## service information

**REF. NO.** 61/4

**SUBJECT:** MODEL 124.036  
ENGINE COMPARTMENT PANELING

- 1 Engine compartment panel
- 2 Wheelhouse liner

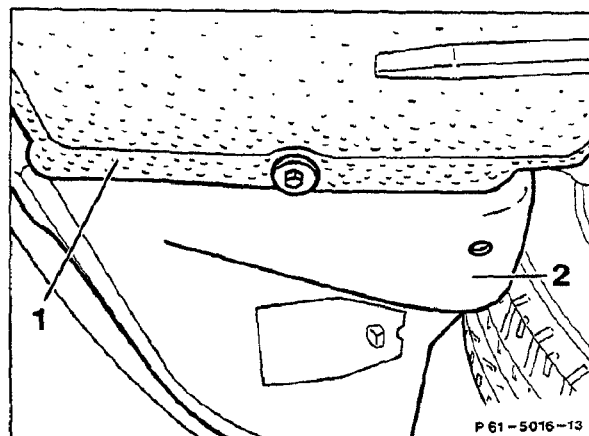
On some vehicles the lower engine compartment panel was incorrectly installed during production. The panel projects into the sides of the wheelhouse liners instead covering them from below.

During the next maintenance requiring the removal of the lower engine compartment panel (1), make certain that you reinstall it in a such way that it will cover the left and right side wheelhouse liner (2) as illustrated. To do so, install the sheet metal clip nuts of the engine compartment panel on the wheelhouse liners.
